TO: CRAIG BARR, QUEENSTOWN LAKES DISTRICT COUNCIL

SUBJECT: QLDC LANDSCAPE CATEGORISATION LINES

REPORT PREPARED BY: PAUL SMITH (LANDSCAPE ARCHITECT)

DATE: 20TH JULY 2015

REF: 0975 - App1
 DATE: 20.07.2015
 SCALE: NOT TO SCALE

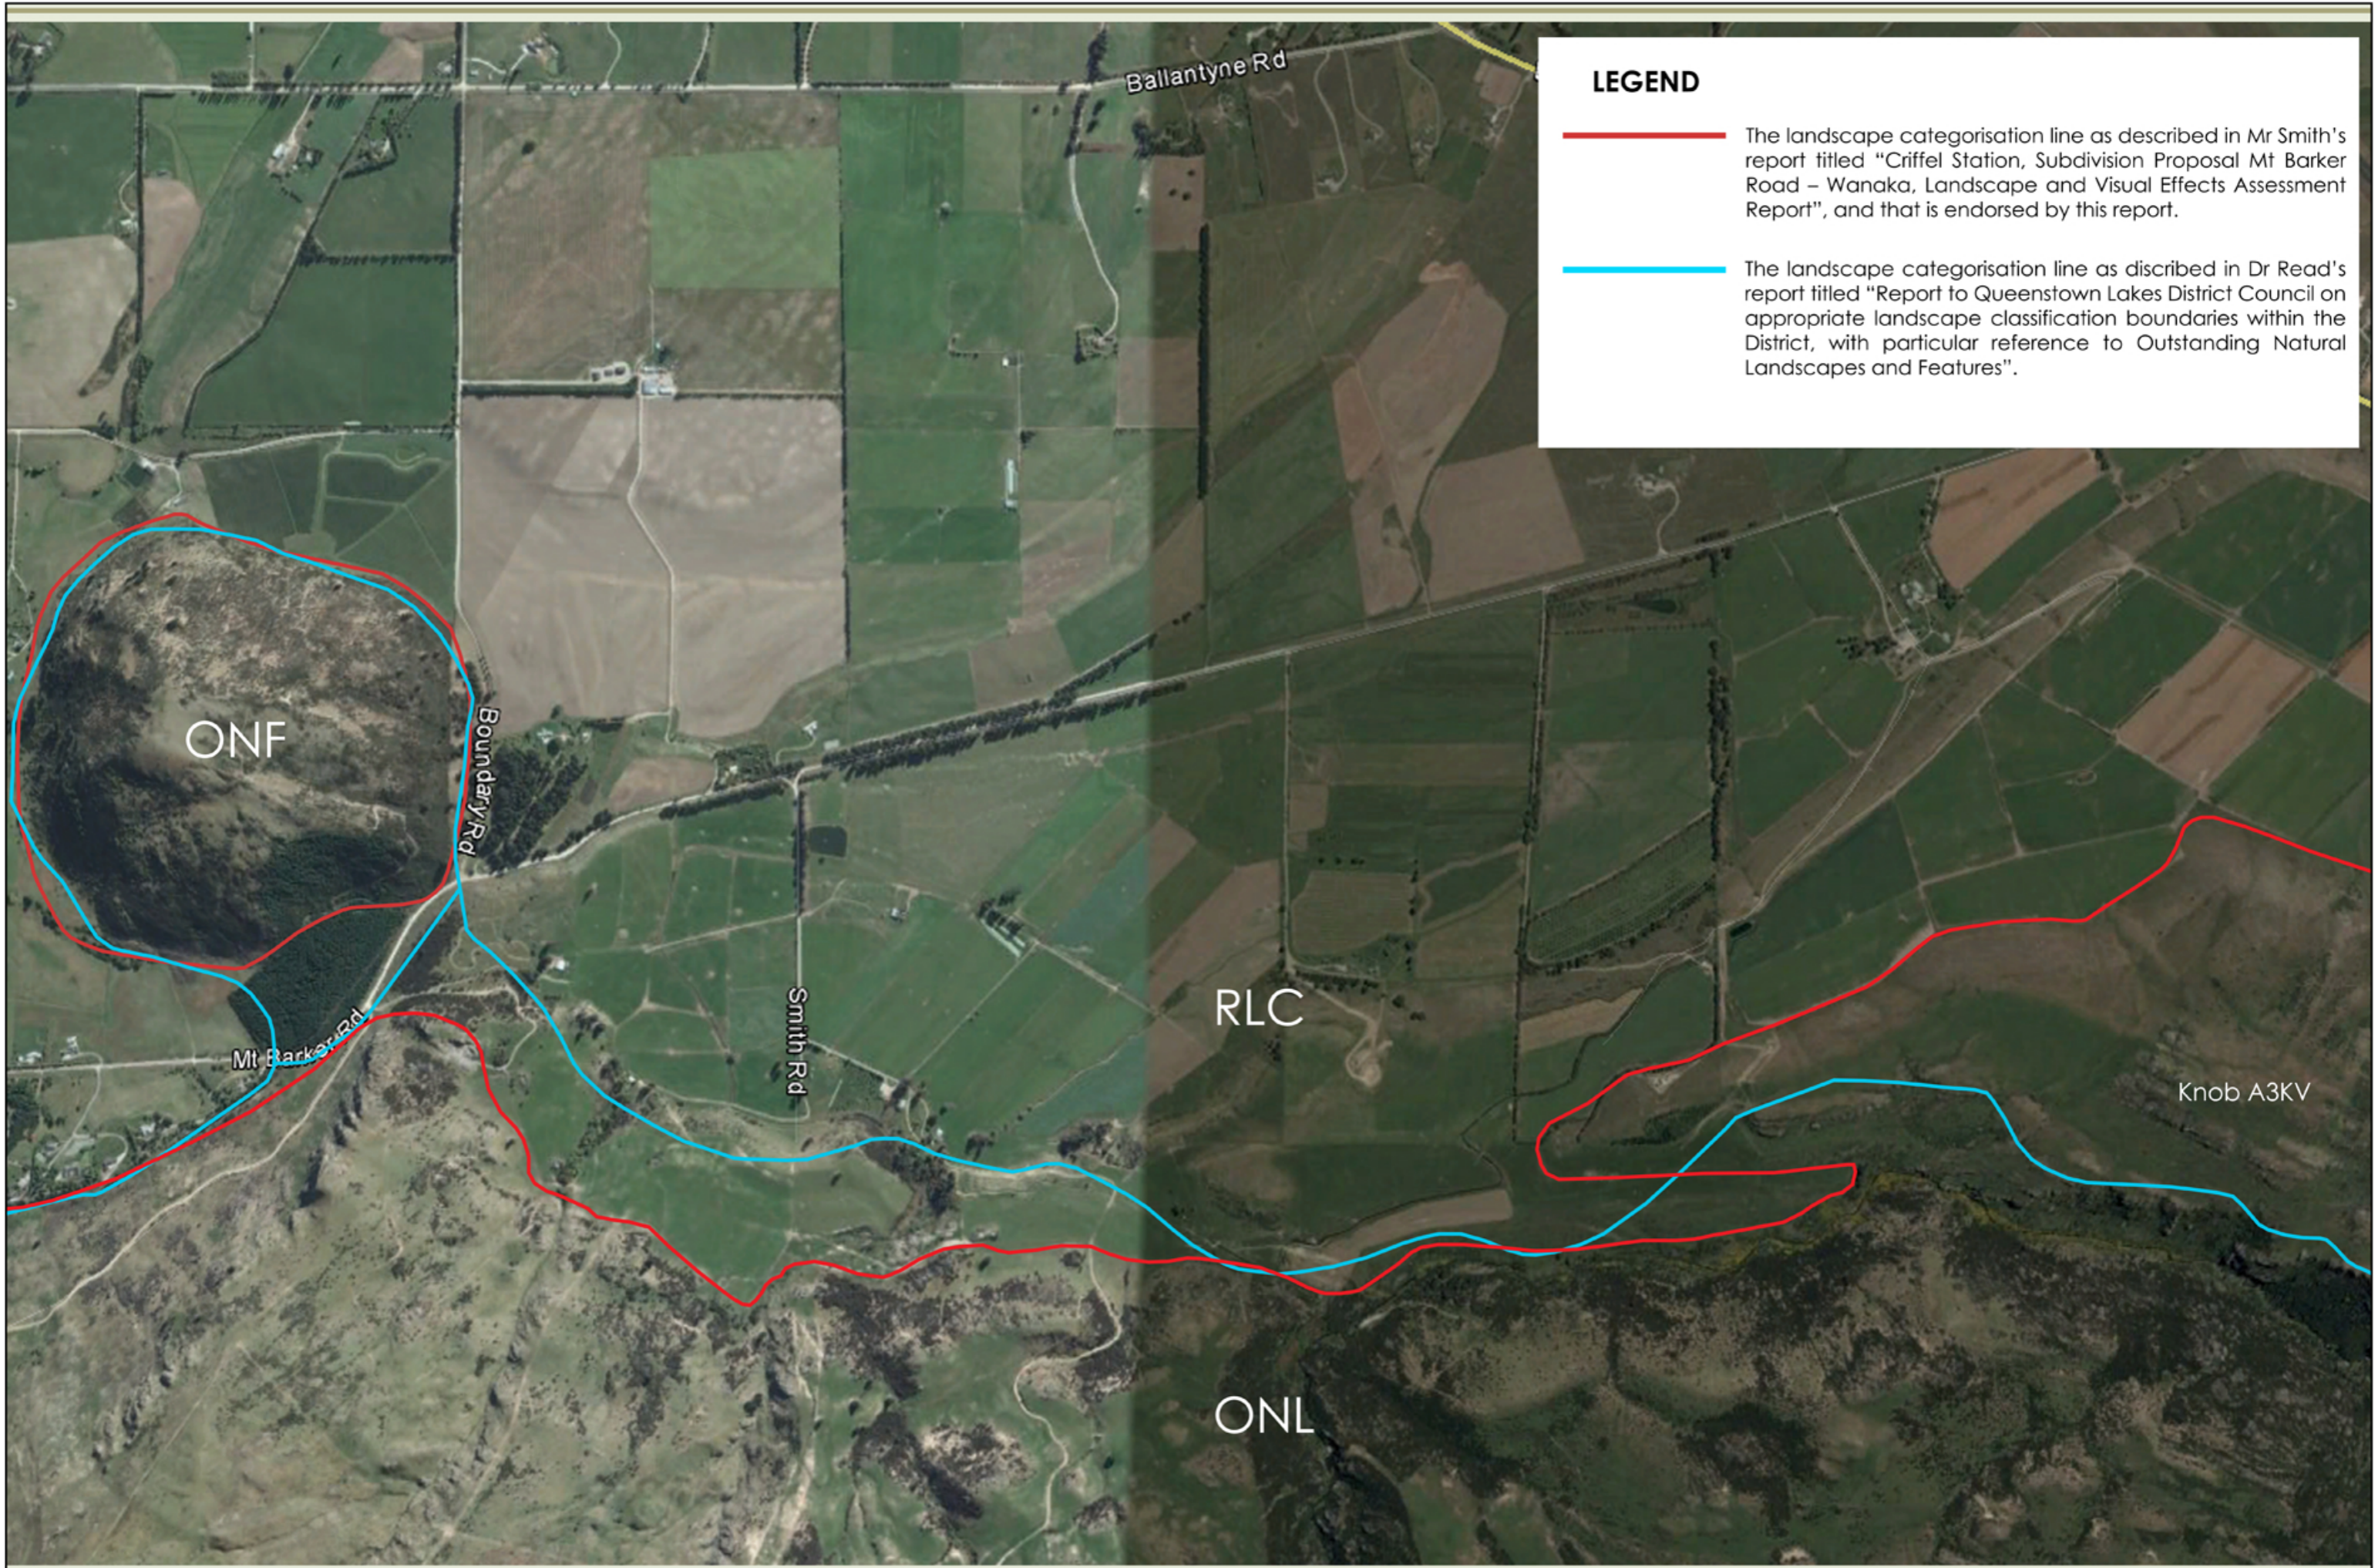
10. The landscape categorisation line as shown on Appendix 2 of my 2014 report is shown on Appendix 1 and 2 of this memo. I disagree with Dr Read's landscape categorisation line for the following reasons:

- Dr Read's line ascends/descends the escarpment face immediately east of Smith Road in a way that does not relate to landform. Dr Read's line does not consistently follow the toe or the top of the escarpment.

- The terrace that Dr Read considers to be part of the ONL(DW) is a relatively small part of the overall terrace system located at the toe of the Criffel Range. Dr Read considers the remainder of this relatively large terrace not to be categorised as part of the ONL.

- Dr Read's line bisects a flat paddock area of the terrace, in a way that is unrelated to landform, so as to include a bluff system immediately west of Knob A3KV.

- The bluff system has similar landscape characteristics to much of Knob A3KV, however Dr Read does not include Knob A3KV in the identified ONL.

11. Taking into account all of the above, I consider that the landscape categorisation boundary line should be drawn as shown by the red line on Appendix 1 and 2 of this memo.
12. In summary, the vast, open, rugged, steep, extensively farmed mountain slopes of the Criffel Range have a landscape character that is consistent with an ONL categorisation. The flat, verdant, intensively farmed terraces and valley floor have a landscape character that is consistent with a RLC categorisation.

Appendix 3: Landscape Categorisation Lines

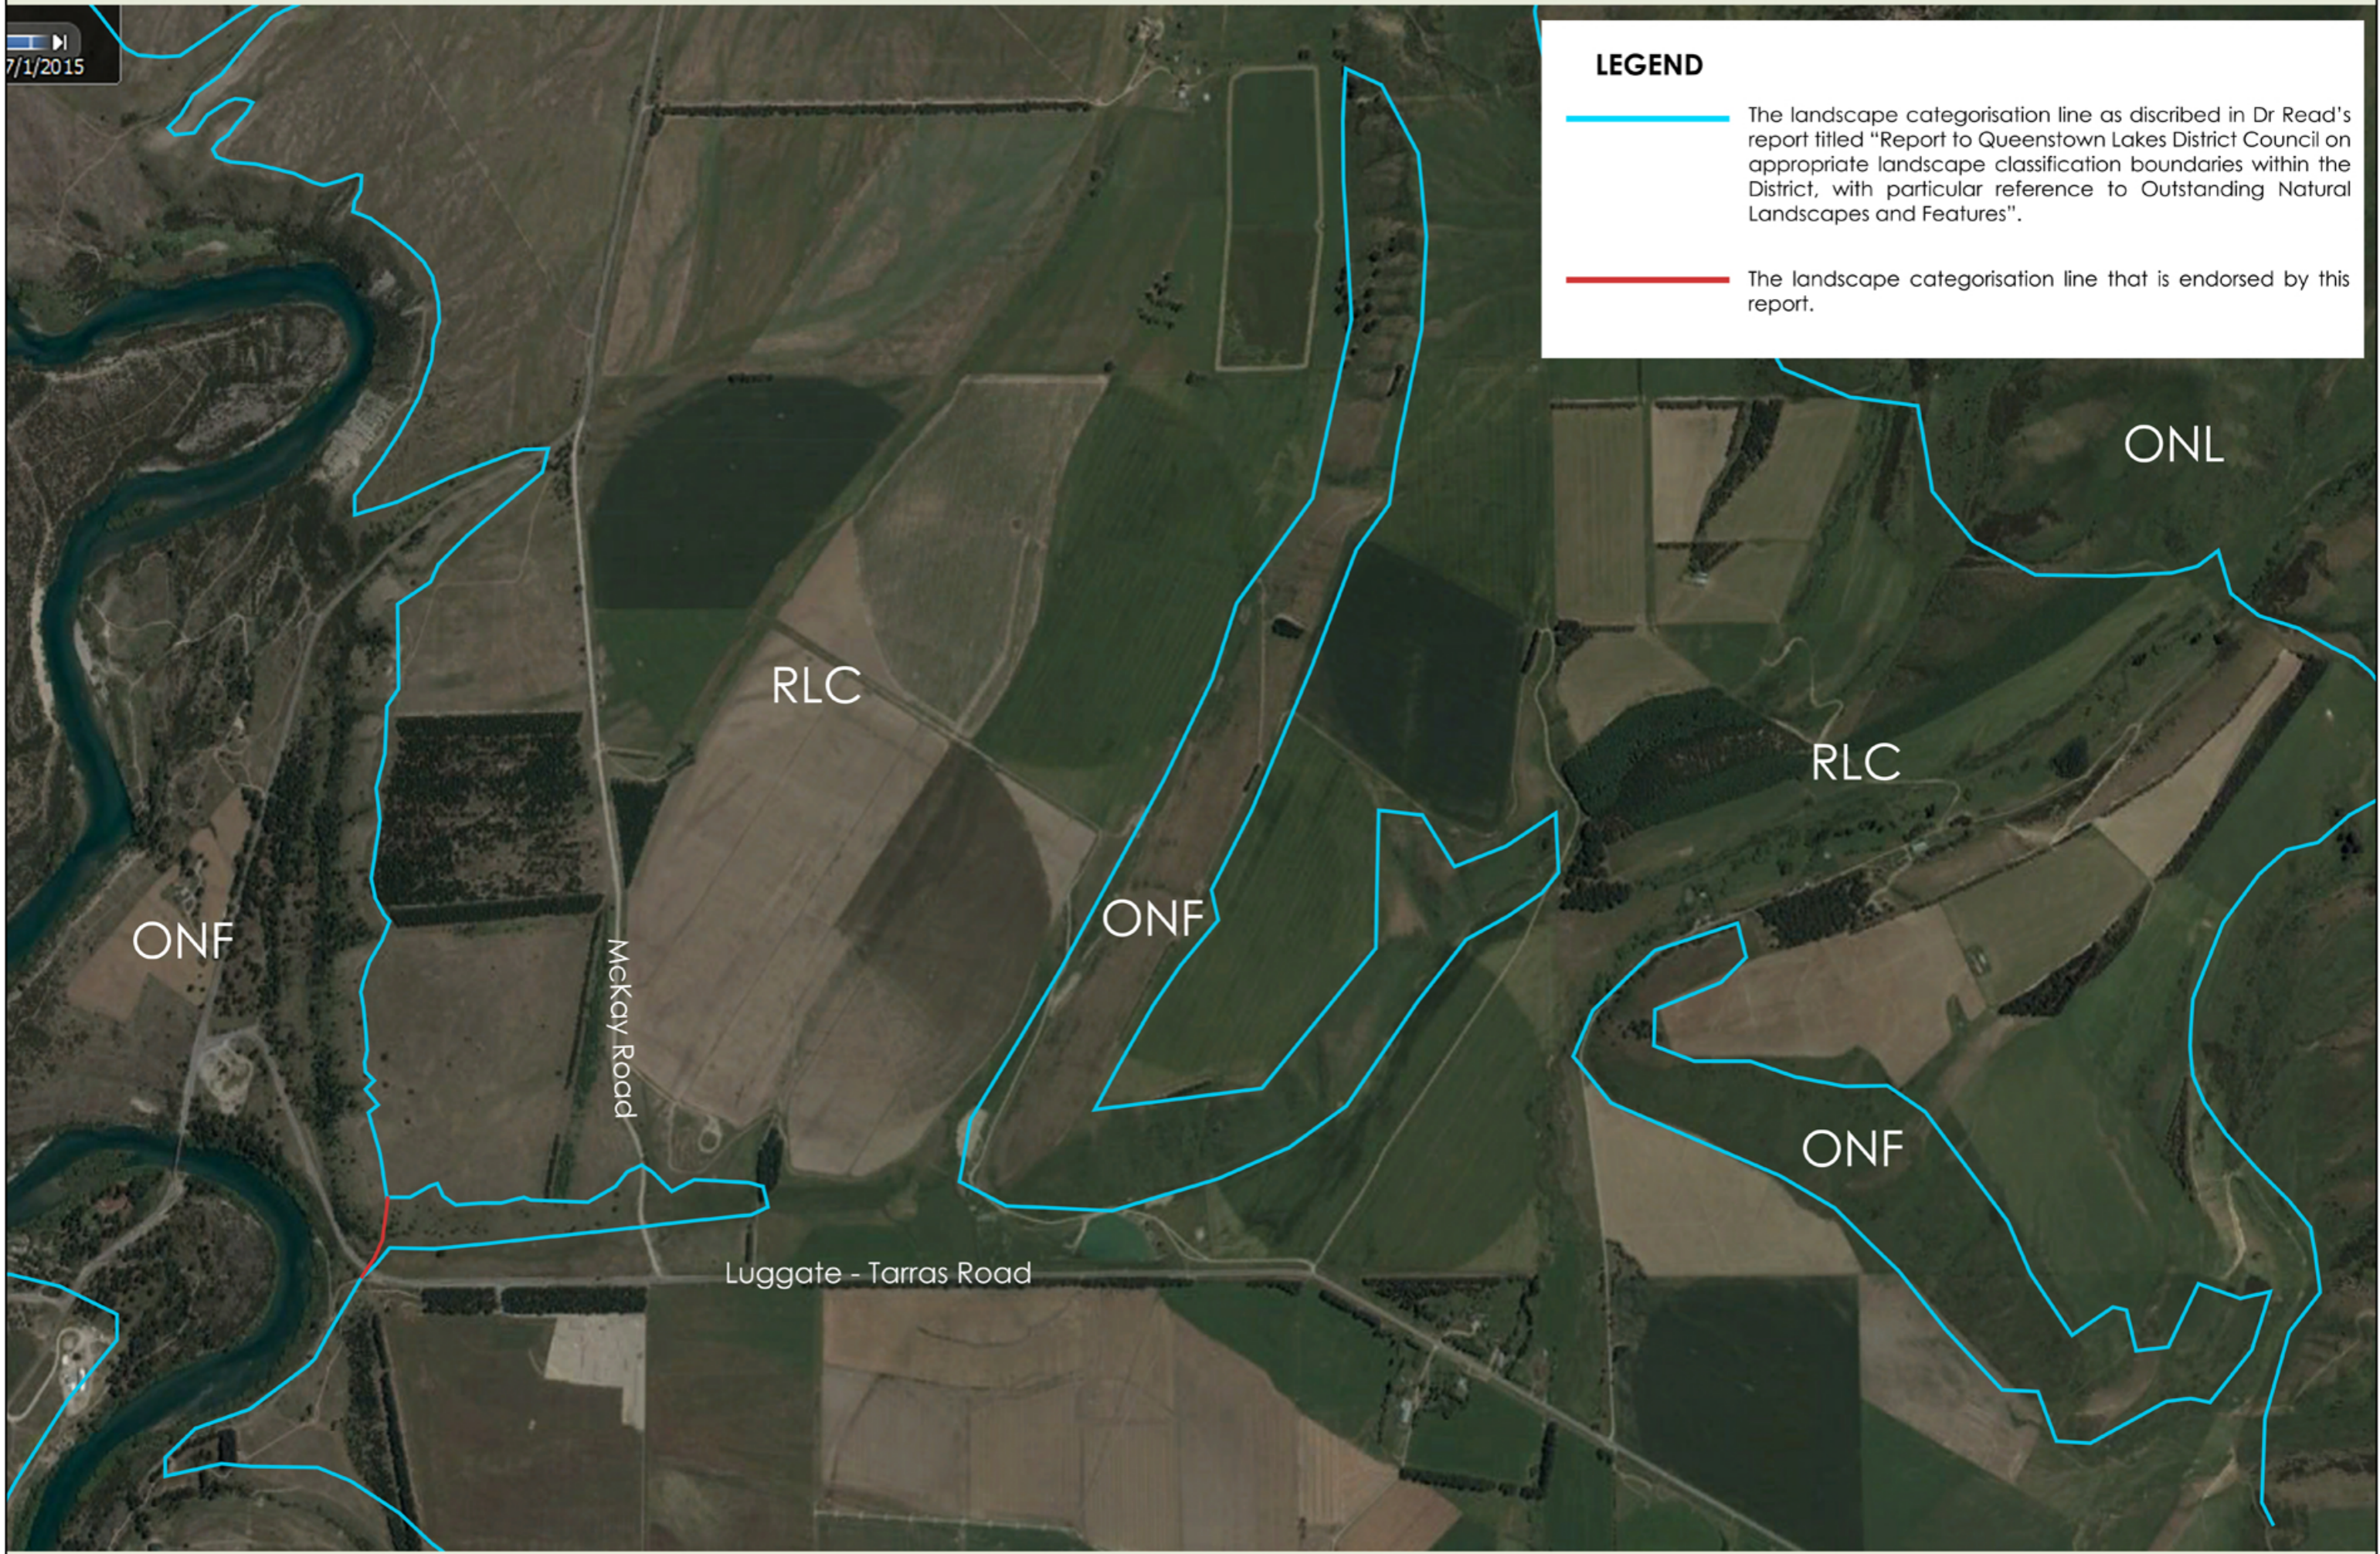
13. Part of an escarpment face located within the vicinity of the McKay and Luggate-Tarras Road intersection has been categorised as being an ONF, as can be seen on Appendix 3. The two escarpment faces that separate the large terrace system located south-west of the

16. I disagree with Dr Read adopting these escarpment faces as being ONFs for the following reasons:

- ONFs identified within the Queenstown Lakes District include hills, river corridors, islands, lakes and other natural features that are distinct from their surroundings. Examples include the Shotover Gorges, Roys Peninsula, Mt Iron, Mt Barker and Slope Hill. The escarpment faces in question are part of the terrace system that extends south-west of the Grandview Mountains. They are inextricably linked to the terrace tread and to the greater landscape. I do not consider that they are

sufficiently distinct from their context to be considered as features. They are not independent from their surroundings.

- The relevant escarpment faces are geomorphologically legible and are visually interesting. However, I do not consider that they can be said to stand out from the rural landscapes and features of the district in terms of landscape merit. They are simply not remarkable or valuable enough to be termed outstanding. To do so would be to devalue the term outstanding within our district; to set the bar to low which may have significant consequences. Obviously it is the case that there are many visually prominent and geomorphologically interesting parts of our rural landscapes that are valued in their current state. This does not mean that we need to stretch the definition of the term outstanding to include them. They can sit comfortably within our non ONL landscapes and still gain appropriate protection by the District Plan's provisions.

- The escarpment face separating the elevated terrace at the toe of the Criffel Range from the Upper Clutha Basin that lies further to the north has not been categorised by Dr Read or Ms Steven as ONL or ONF. This seems inconsistent and weakens the case for the identified escarpments to be included.

- The vegetation cover on these escarpment faces varies. There is some native grey shrub cover but there is also considerable pasture grass cover. Again I consider this weakens the case that the escarpment faces are distinct features or are outstanding.

17. In summary, the escarpment faces that have been identified by Dr Read are simply parts of the greater landscape in the way that many escarpments or other pieces of landform throughout the district are. They are not significantly distinct from their surroundings to be features in their own right. Similarly they are not remarkable enough in terms of natural, physical, perceptual or associative factors to be termed outstanding. I consider they should be categorised as the surrounding landscape.
